NRC DOCKET 50-366  
OPERATING LICENSE NPF-5  
EDWIN I. HATCH NUCLEAR PLANT UNIT 2  
PROPOSAL FOR TECHNICAL SPECIFICATION CHANGES  
PURGE VALVE OPERATION

NRC DOCKET 50-321  
OPERATING LICENSE DPR-57  
EDWIN I. HATCH NUCLEAR PLANT UNIT 1  
PROPOSAL FOR TECHNICAL SPECIFICATION CHANGES  
PURGE VALVE OPERATION

18" PURGE/VENT LINE EXCESS FLOW ISOLATION DAMPERS

PURGE AND VENT SYSTEM

UNIT #1  
 NOTE 1 EXCESS FLOW ISOLATION DAMPERS  
 NOTE 2 T48 UNLESS OTHERWISE NOTED  
 ---- NEW EQUIPMENT  
 FIGURE NO. 1

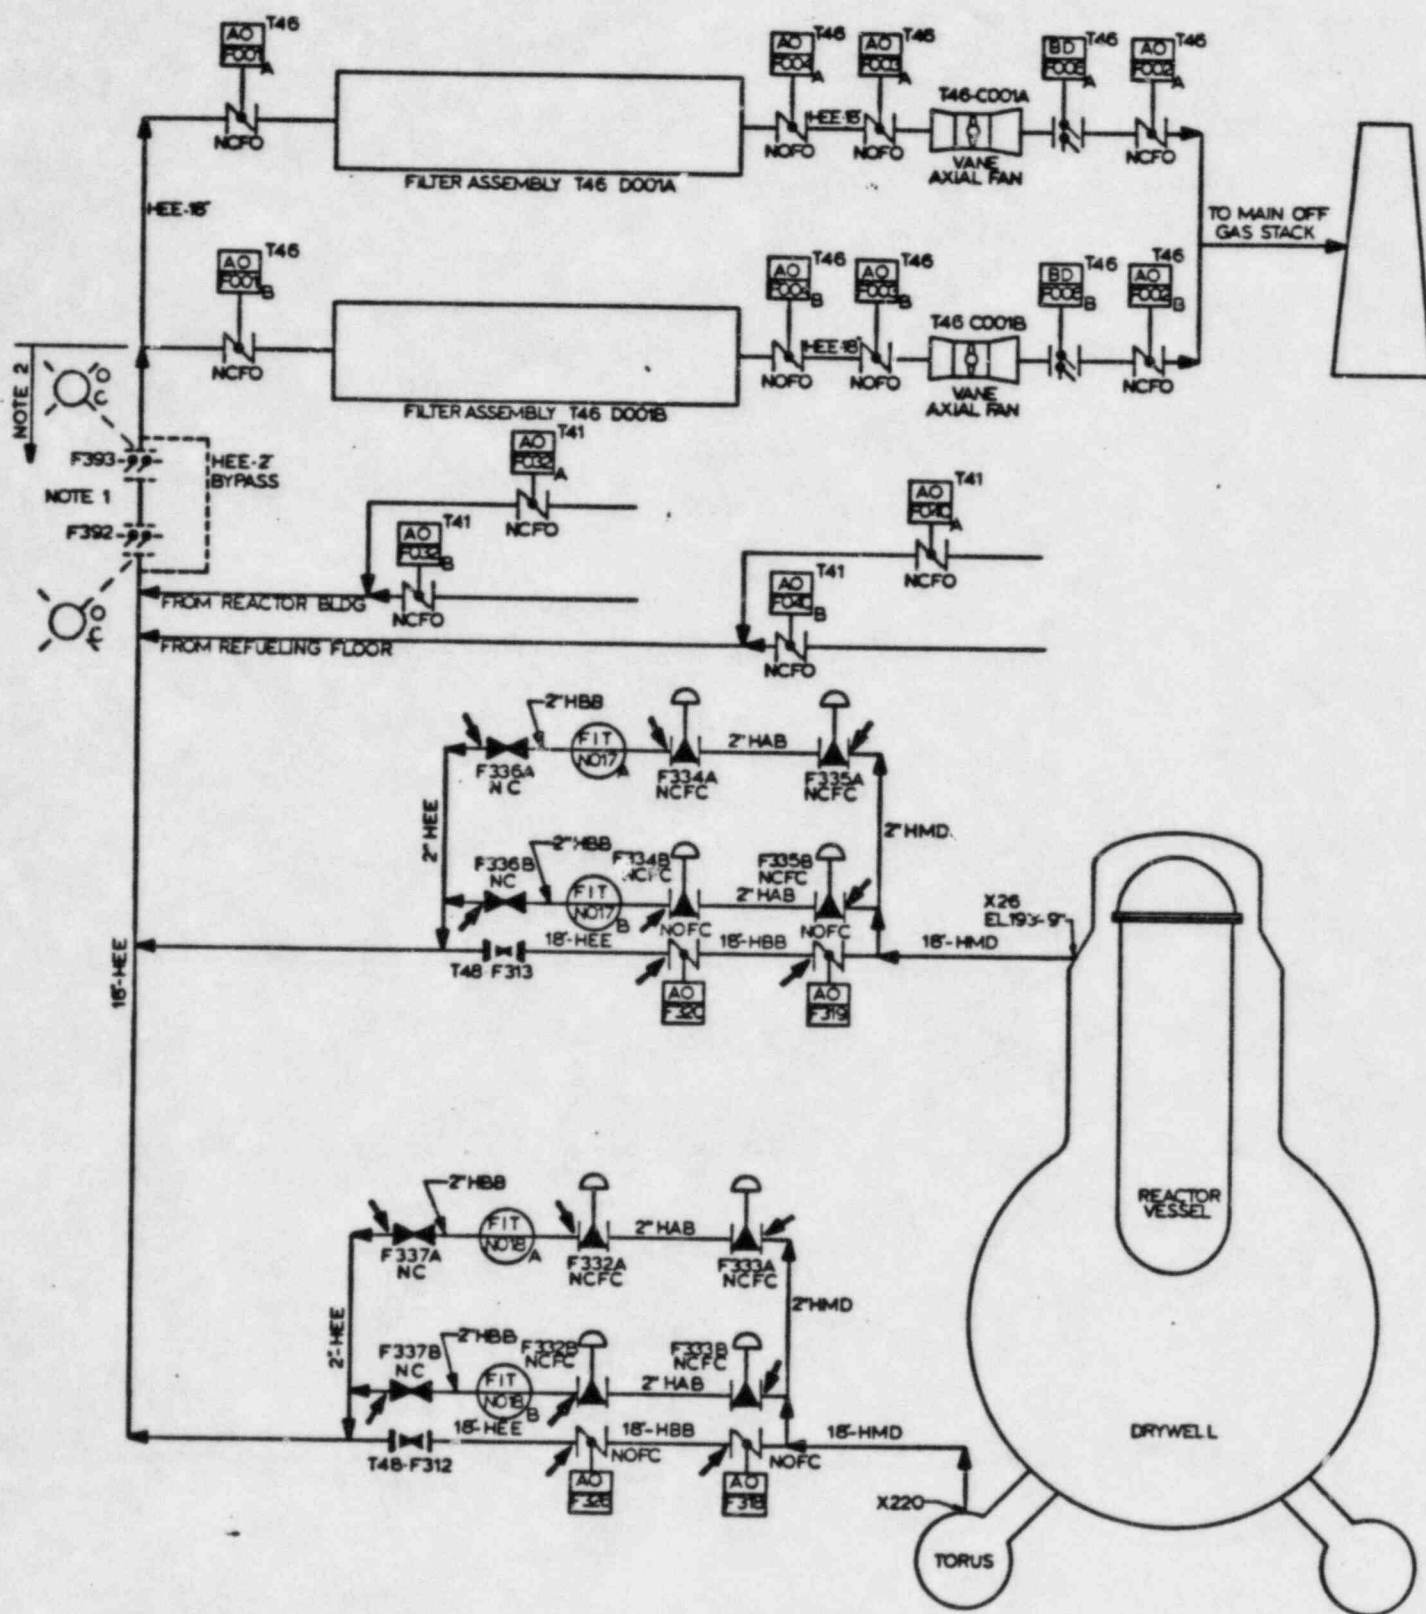
To assure that post LOCA venting capabilities are maintained, a 2 inch bypass line will be installed around the isolation dampers as shown on figures 1 and 2. Calculations have demonstrated that the SGTS filters will not be overpressurized with the 2" bypass line.

These dampers will not be containment isolation valves. Containment isolation capabilities are provided by the existing valves. For unit 1 from figure 1 these valves are T48-F318, F319, F210 and F326. For unit 2 from figure 2 these valves are 2T48-F318, F319, F320 and F326. These containment isolation valves will close within 5 seconds post LOCA.

PHOTOGRAPH 1

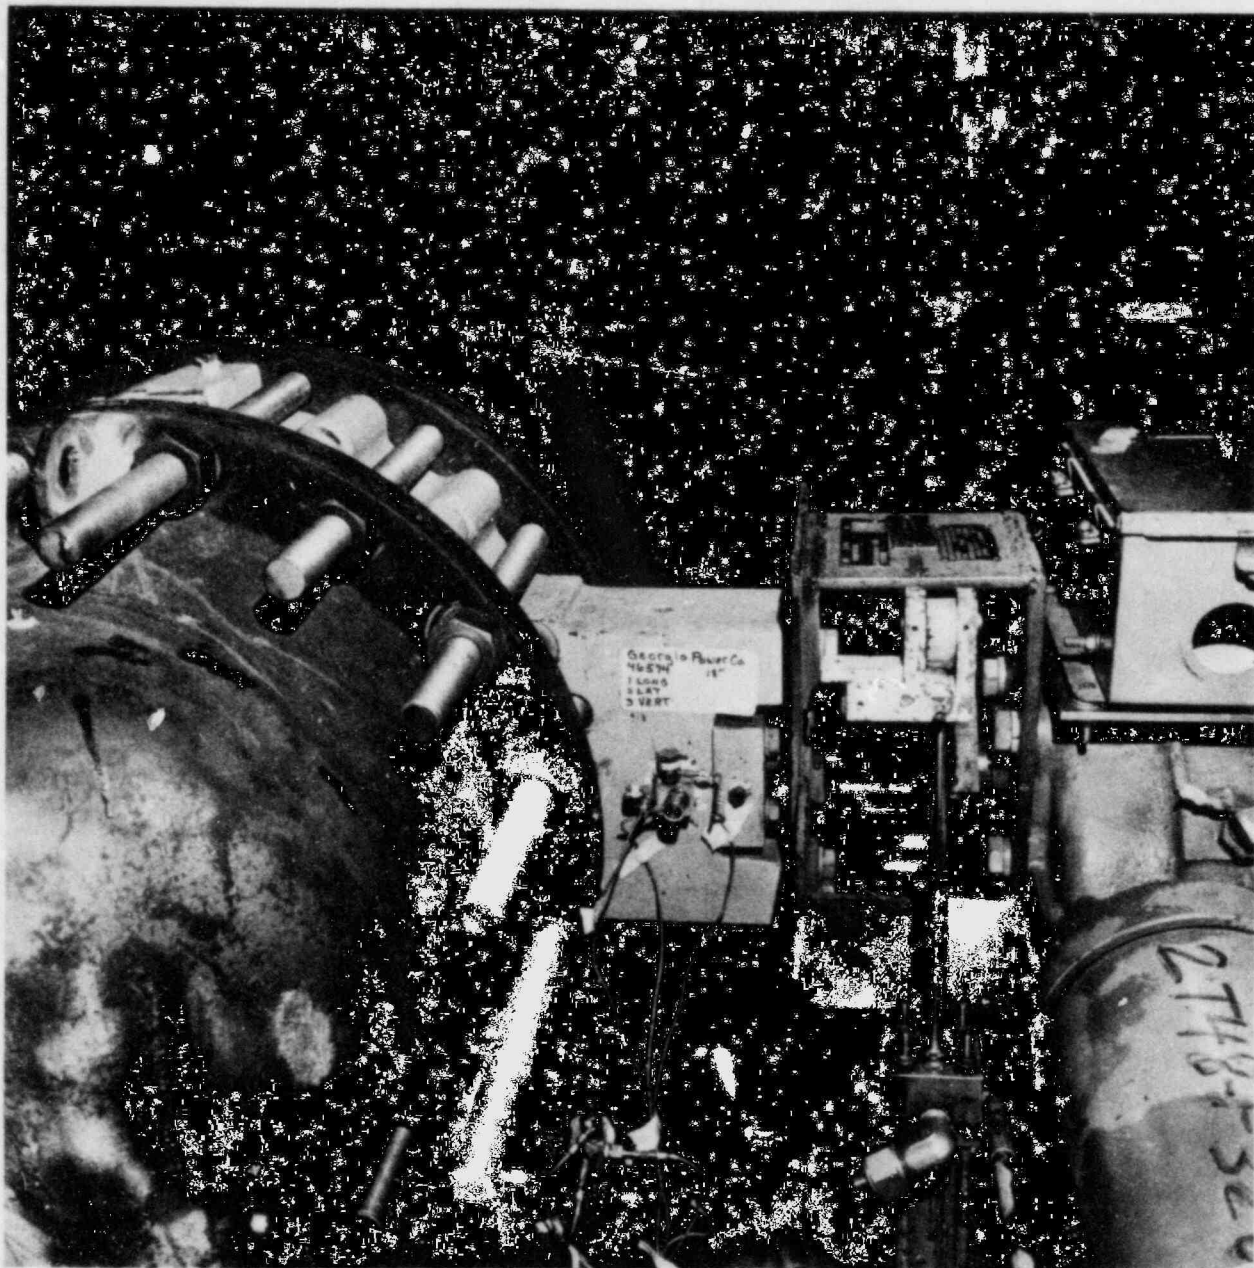
Six accelerometers were mounted on the valve assembly, three at the valve - actuator connecting bracket, refer to photograph 1, and three at the end of the actuator, refer to photograph 2.

## MODEL 733 B-SR

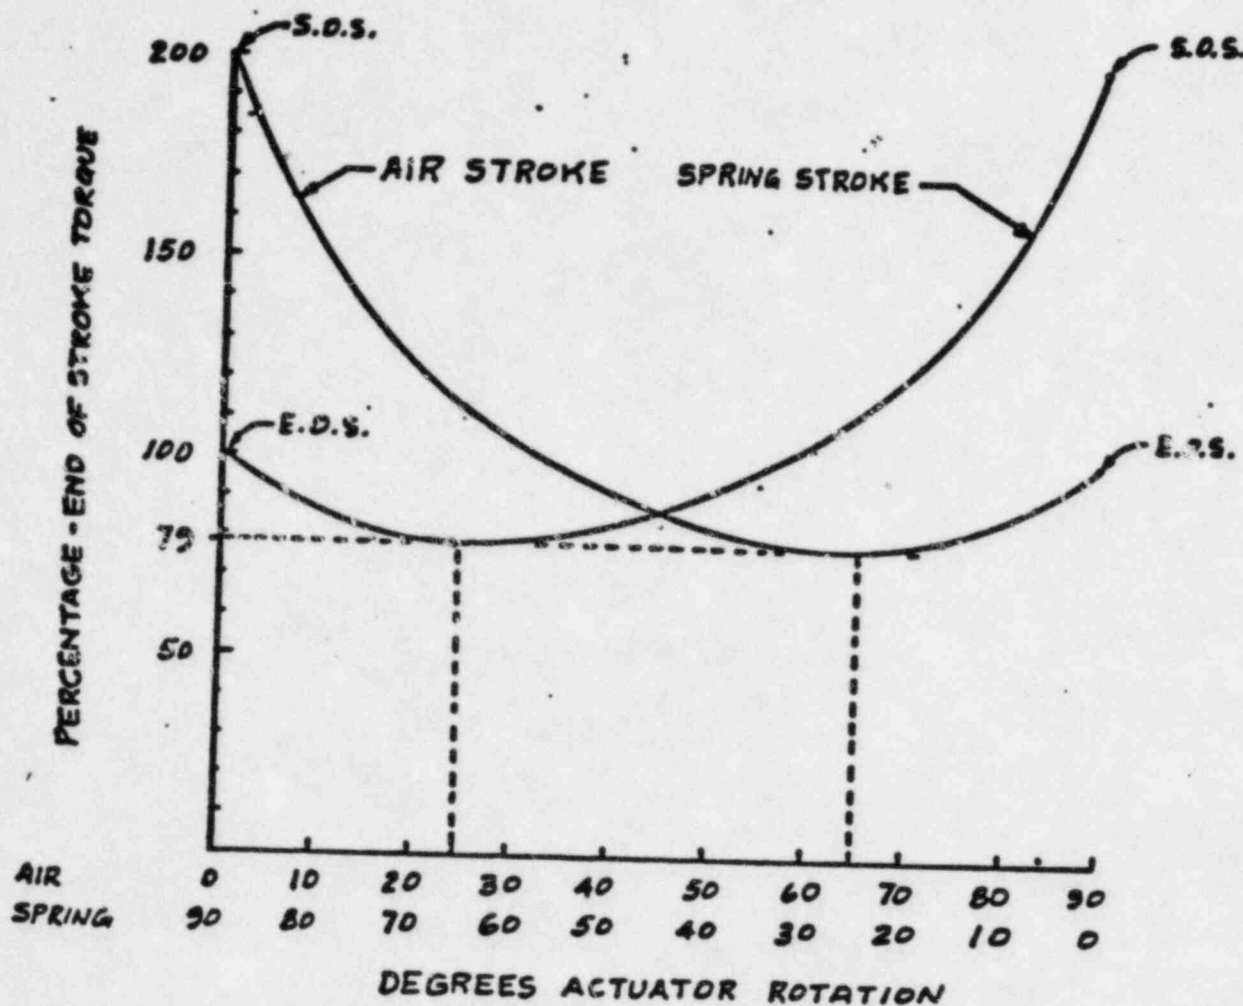
- e. A marked diagram of a Bettis Type 733B-SR actuator is enclosed, showing the suggested location of the travel stop. The air breather and body plug should be removed from the spring barrel end, and the end of the spring barrel should be re-bored and re-threaded to take a travel stop (machined from bar stock).
